UNITED STATES PATENT AND TRADEMARK OFFICE

APPLICATION NO.	FILING DATE	FIRST NAMED INVENTOR	ATTORNEY DOCKET NO.	CONFIRMATION NO.
10/669,457	09/25/2003	Barry E. Gilman	GIL001-101	4612
7590	01/09/2006		EXAMINER	
DIEDERIKS & WHITELAW, PLC 12471 Dillingham Square, #301 Woodbridge, VA 22192			NELSON, JAMES T	
			ART UNIT	PAPER NUMBER
			3637

Office Action Summary	Application No.	Applicant(s)	
	10/669,457	GILMAN, BARRY E.	
	Examiner	Art Unit	
	James T. Nelson	3637

Jezirowski, Fig. 1

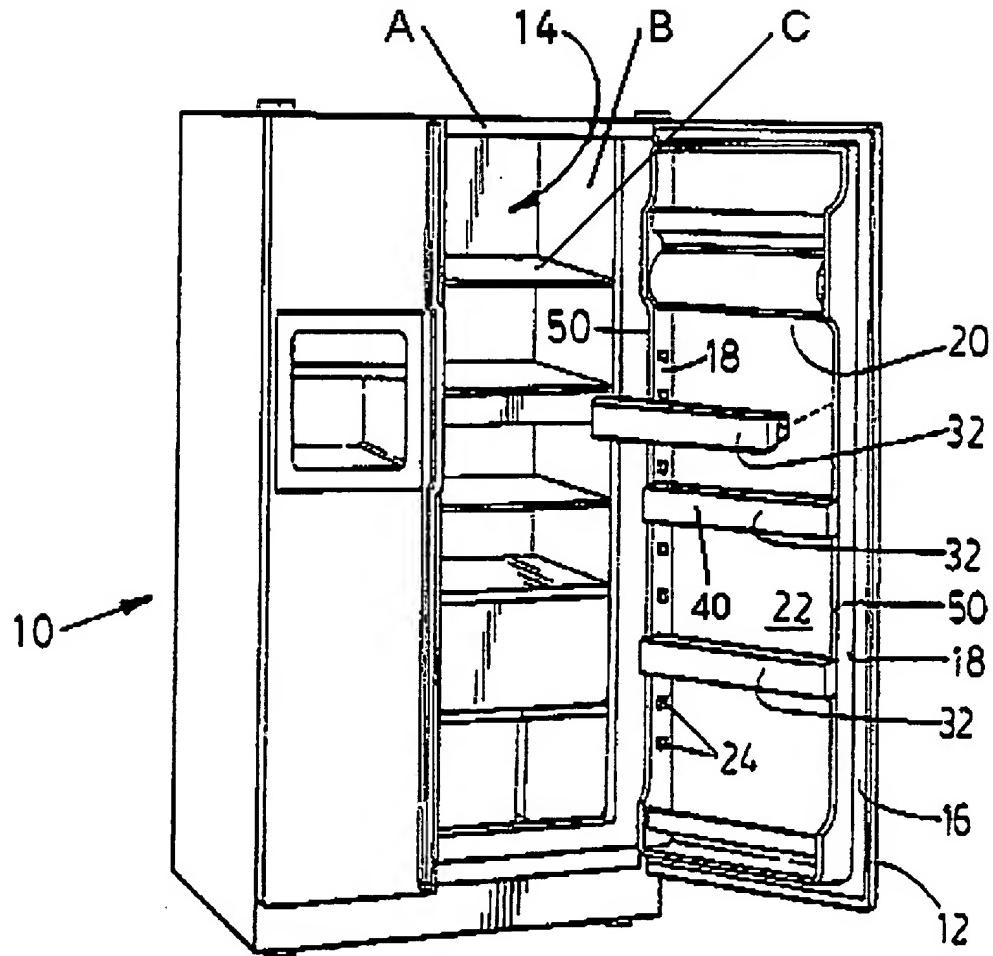
3. Regarding claim 1: In Fig. 1, Jeziorowski shows a refrigerator (10) comprising: a cabinet shell (A), a liner (B) arranged in the cabinet shell (A) and defining a compartment (14), a door (12) attached to and movable relative to the cabinet shell (A) in order to selectively access the compartment (14), and at least one shelving unit (32) provided in the compartment (14), said at least one shelving unit (32) being adapted to support items thereon. Jeziorowski lacks a retainer assembly for securing items on the at least one shelving unit, said retainer assembly including a divider element mounted for movement along a defined axis relative to the at least one shelving unit and dividing the at least one shelving unit into first and second laterally spaced storage zones, and a biasing member urging the divider element in a predetermined direction, wherein items positioned on the at least one shelving unit are automatically engaged by the divider element in order to be maintained in a snug configuration in the first storage zone while maintaining the second storage zone available as additional storage space. In Fig. 6, the German document teaches a retainer assembly for securing items on the at least one shelving unit, said retainer assembly including a divider

4. Regarding claim 2: In Fig. 1, Jeziorowski, as modified by the German document and Rankin, shows the refrigerator according to claim 1. The German document also teaches a retainer assembly further including a support arm (8) extending from the divider element (6), said support arm mounting the divider element for sliding movement relative to the at least one shelving unit.
5. Regarding claim 3: In Fig. 1, Jeziorowski shows a refrigerator (10) comprising: a cabinet shell (A), a liner (B) arranged in the cabinet shell (A) and defining a compartment (14), a

6. Regarding claim 4: In Fig. 1, Jeziorowski, as modified by the German document and Rankin, shows the refrigerator according to claim 3, wherein the at least one upstanding wall (40) constitutes a front wall (40) of the door pick-off bucket (32).

7. Regarding claim 5: In Fig. 1, Jeziorowski shows a refrigerator (10) comprising: a cabinet shell (A), a liner (B) arranged in the cabinet shell (A) and defining a compartment (14), a door (12) attached to and movable relative to the cabinet shell (A) in order to selectively access the compartment (14), and at least one shelving unit (32) provided in the compartment (14), said at least one shelving unit (32) being adapted to support items thereon. Jeziorowski lacks a retainer assembly for securing items on the at least one shelving unit, said retainer assembly including a divider element mounted for movement along a defined axis relative to the at least one shelving unit and dividing the at least one shelving unit into first and second laterally spaced storage zones, and a biasing member urging the divider element in a predetermined direction, wherein items positioned on the at least one shelving unit are automatically engaged by the divider element in order to be maintained in a snug configuration, wherein the biasing member constitutes a spiral spring extending directly along a wall of the at least one shelving unit. In Fig. 6, the German document teaches a
